**GROUP A BCAC
MOE Work Group
OCTOBER 2-3, 2018
REPORT FOR PUBLIC COMMENTS**

Fig. 1 – IBC Sec. 1006.3.2 prevents this configuration

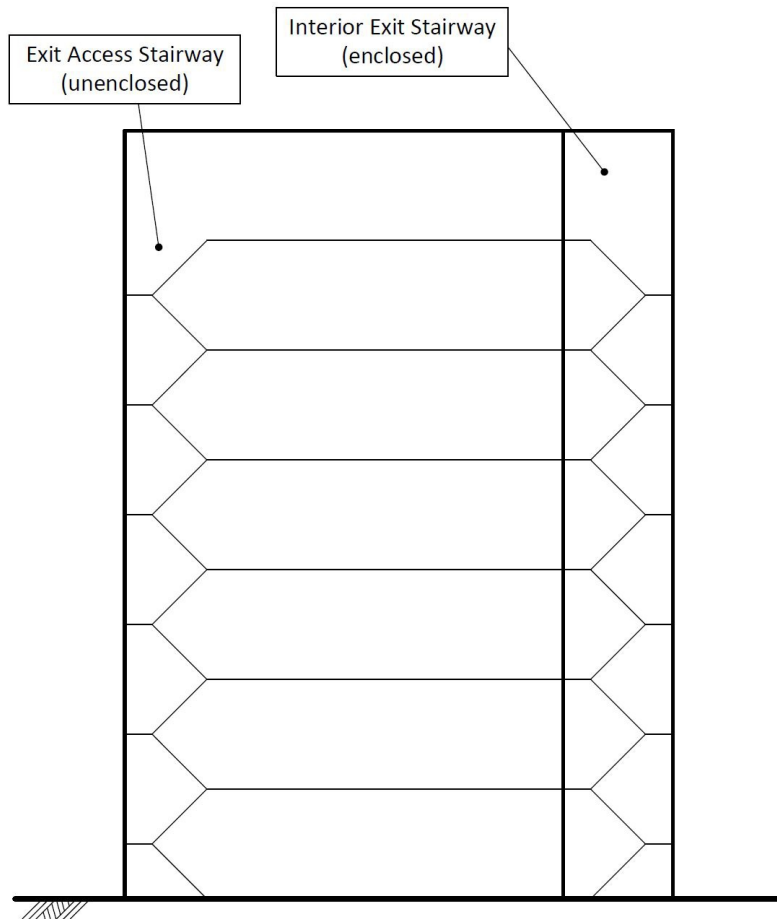
The charging language in Section 1006.3.2 (using the numbering system proposed by this code change proposal) was originally introduced to prevent situations shown in Figure 1 below. This figure illustrates a multi-story building that has one (enclosed) interior exit stair and one (unenclosed) exit access stairway. Prior to the introduction of the code text in 1006.3.2, the code would have allowed this situation in a B or M occupancy. (Recall that in a B or M Occupancy, an unenclosed exit access stairway is not limited in height.)

Section 1006.3.2 essentially requires a path of egress to transition from an unenclosed exit access stairway to an interior exit stair within one story. Note that this principle of transitioning from an unenclosed exit access stairway to an (enclosed) interior exit stair in the adjacent story below was cited in the reason statement for Code Change Proposal E27-15, and was upheld by the Means of Egress Committee in Columbus in their disapproval of Code Change Proposal E20-18 by a 14-0 vote. The reason they gave for disapproval was, "The exceptions that permit the travel on exit access stairways to go more than one story were carefully considered. This should not be extended to stairways with draft curtains or atriums. This is too great of an opportunity for smoke migration within high rise buildings."

Fig. 2 - E18-18 As Modified – Occupied Roof Served by Exit Access Stairway

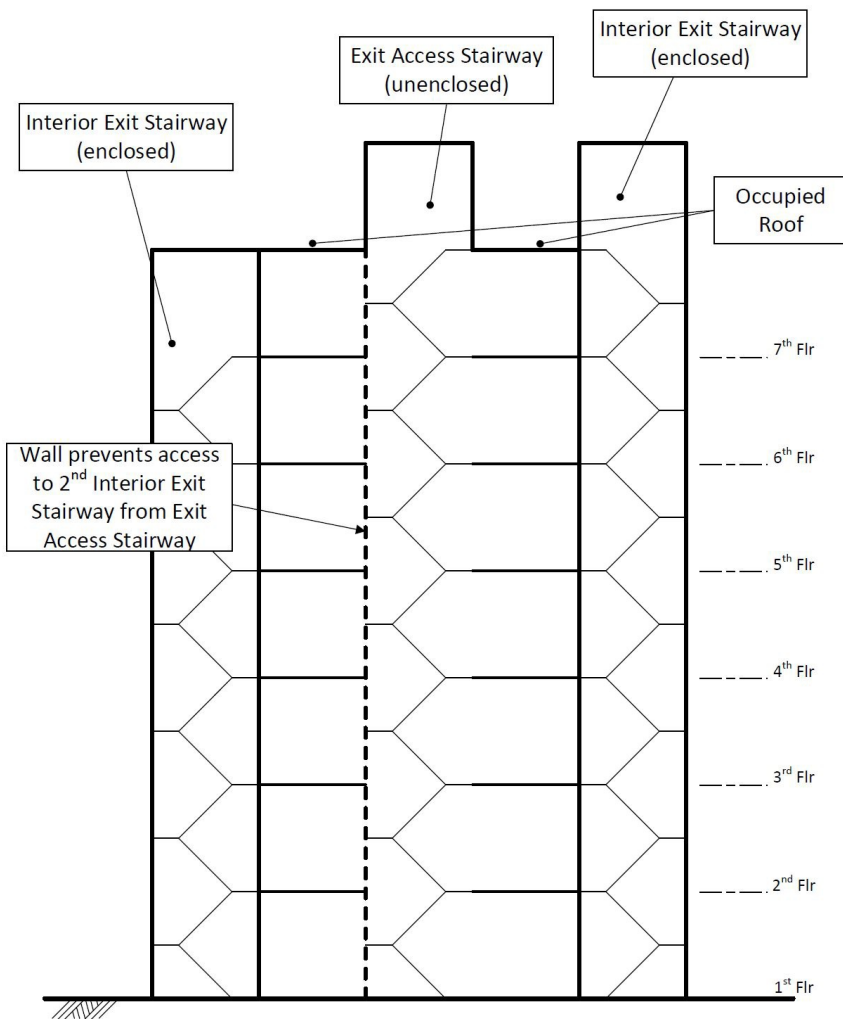
However, this proposal with the floor modification approved by the Committee would allow a similar, dangerous situation for a roof deck, as shown in Figure 2. This figure depicts a multi-story building with an occupied roof. All stories have access to the two interior exit stairs. The occupied roof is served by an interior exit stair (on the right), and an unenclosed exit access stairway. Because the modification introduced on the floor at the Committee Action Hearings in Columbus exempts stairs serving an occupied roof from the shall not pass through more than one adjacent story restriction, this means that the unenclosed exit access stairway is not required to transition to the enclosed exit stair on the left of the figure at the uppermost story. That is, the exit access stair could be isolated from the second enclosed exit stair. This is a dangerous precedent to set, as one could argue if an unenclosed exit access stairway of unlimited height (in a B or M occupancy) is allowed to be the second means of egress for an occupied roof, why should there be any restriction on using the same arrangement for a story?

This is not a hypothetical issue, as we in Seattle have recently seen several applications for high rise office building tenants sporting unenclosed convenience stairs extending as many as 10 or 12 stories through the building. In those buildings, it can easily be conceived that the convenience stairs would become the only second means of egress for all the stories they serve. Extending the concept of unenclosed stairs serving an occupied roof to these stories would be done in a heartbeat, if this as-modified proposal were to survive.

Fig. 3 - E18-18 As Submitted – Decks on Different Roof Levels

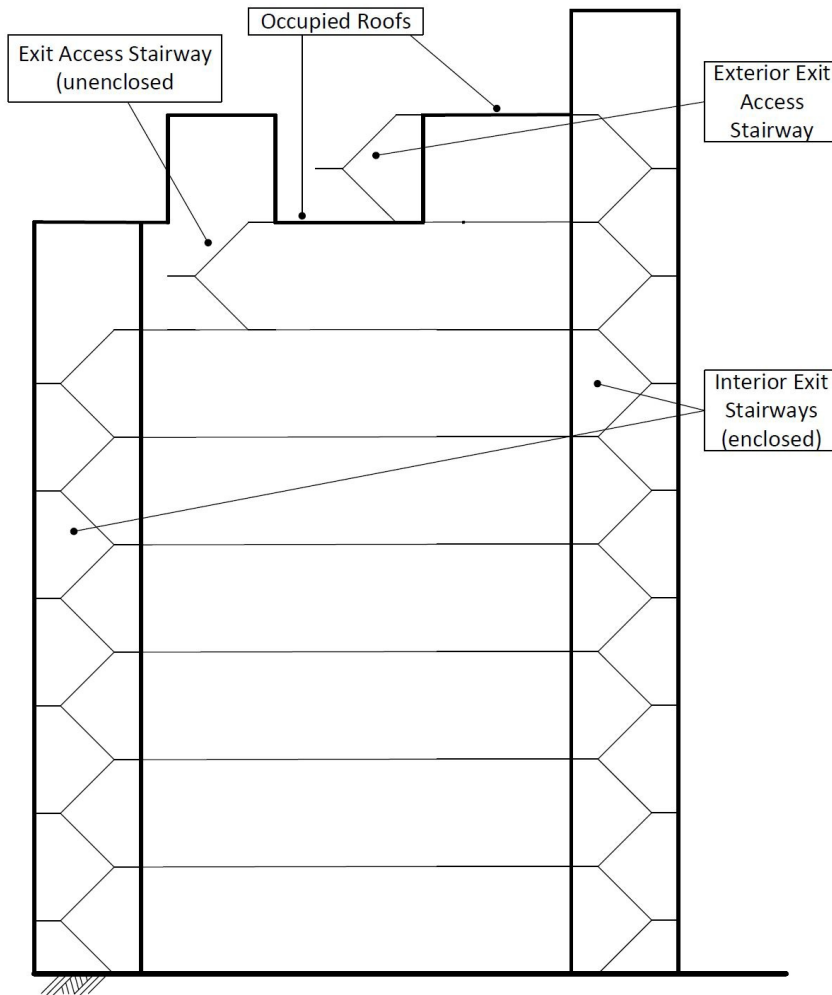
This public comment returns to the originally proposed text of Section 1006.3.2, Exception 7, and Section 1019.3, Exception 9, and keeps them in alignment. We believe the proponent of the original code change had a legitimate issue that is addressed with his proposed language. There are cases of buildings with multiple roof levels with roof decks (Figure 3), or roofs with multiple levels of roof decks (Figure 4) where an exterior stair connecting the occupied roofs need not count toward the one adjacent story, as smoke will not accumulate at those levels.

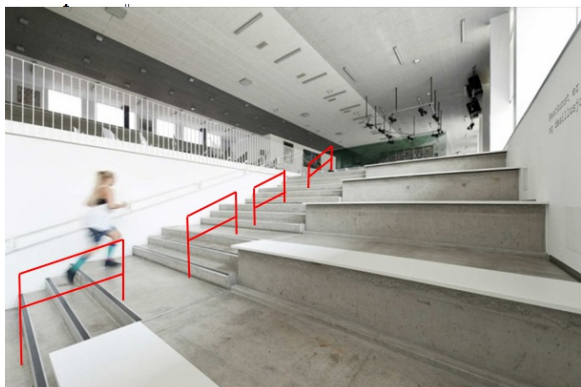
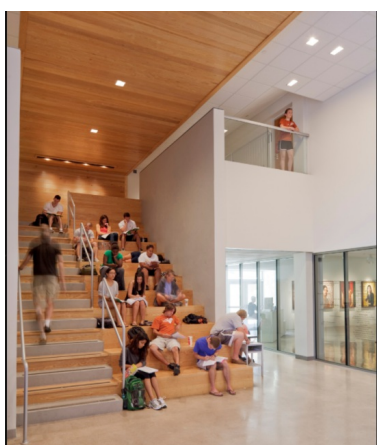
To address the committee's concerns:

The new text in Section 1029.16 and 1029.16.1 will allow for the mid aisle handrail to be the same as for stepped aisles. The term tiered floors will be understood because it is already used in Section 1029.5. The 74 was chosen as the point where a 2nd handrail in the width of the stepped aisle would still allow for movement up and down on each side of the handrail.

The end of the aisle accessways was chosen because the tiered platforms do not always contain seats to measure from. Since the seating areas at stepped aisles are tiered platforms (with or without seats), this may be clearer.

Exception for occupied roof on a building with a horizontal exit.

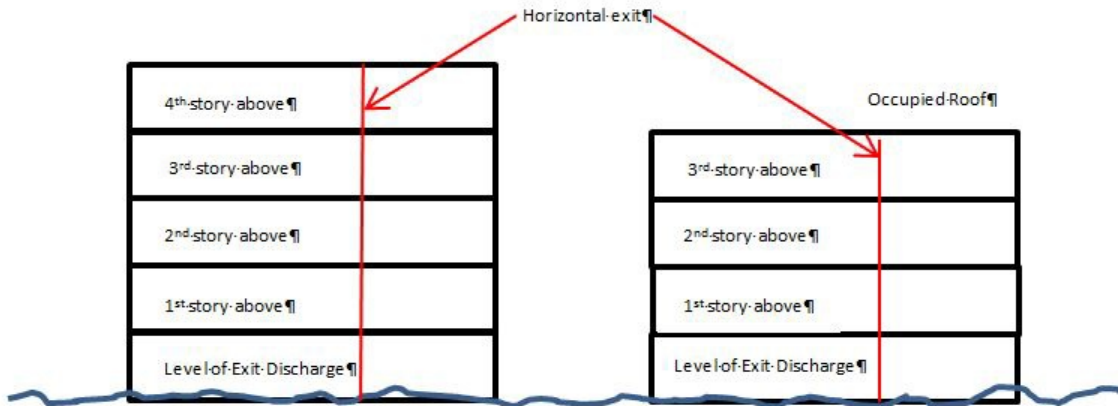
This will not change the original proposal, which will require standby power in a 4 story building with an occupied roof where the building does not have both sprinklers and horizontal exits.

The following is a diagram for illustration of this exception.
